Access Compliance Report

Public Rights-of-Way

(Curb Ramps)

Intersection ID: 18844	Main Street: NATIONS_FORD_RD	Cross Street: TYVOLA_RD	Location: NE
ADA ID: 1E6F941A9A80	Ramp Type: Perp	Initial Pass/Fail: Fail	Overall Compliance: No
		Severity Score: 12.5

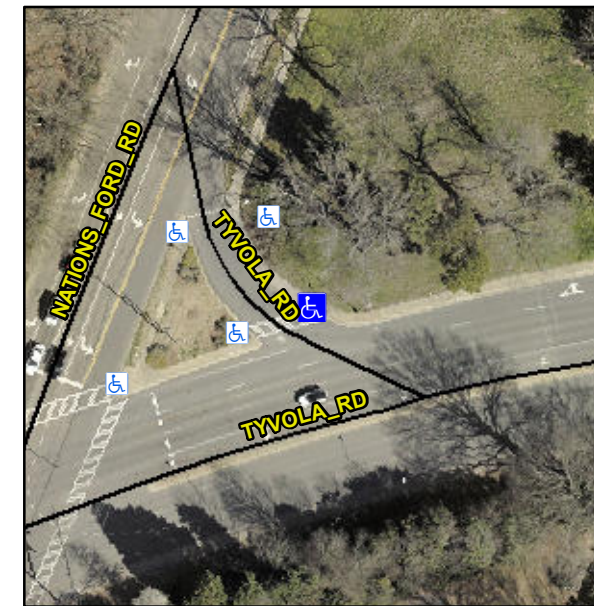
Not Found, R304.2.2

Compliance	Description	Data	Compliance	Description	Data
N/A	Ramp Length (in)	60.0	No	Ramp Slope (%)	8.5
Yes	Ramp Width (in)	48.0	Yes	Ramp XSlope (%)	0.2
N/A	Flare Type LT	N/A	N/A	Flare Type RT	N/A
N/A	Flare Slope LT (%)	N/A	N/A	Flare Slope RT (%)	N/A
N/A	Flare Traversable LT?	N/A	N/A	Flare Traversable RT?	N/A
N/A	Landing Length (in)	N/A	N/A	DWS Provided?	N/A
N/A	Landing Width (in)	N/A	N/A	DWS Contrast?	N/A
N/A	Landing Slope (%)	N/A	N/A	DWS Length (in)	N/A
N/A	Landing X Slope (%)	N/A	N/A	DWS Full Width?	N/A
N/A	Landing Curb? (Y/N)	N/A	N/A	DWS Offset (in)	N/A
N/A	Shared Landing?	N/A			
N/A	Gutter Ponding?	N/A	N/A	Gutter Slope (%)	N/A
N/A	Gutter Lip Ht (in)	N/A	N/A	Gutter X Slope (%)	N/A
N/A	Painted X Walk1?	Yes	N/A	Painted X Walk2?	N/A
	X Walk 1 Direction	To W		X Walk 2 Direction	N/A
N/A	X Walk 1 Width (in)	78.0	N/A	X Walk 2 Width (in)	N/A
	X Walk 1 Slope (%)	1.8		X Walk 2 Slope (%)	N/A
	X Walk 1 X Slope (%)	1.1		X Walk 2 X Slope (%)	N/A

Remove & Replace Entire Ramp.
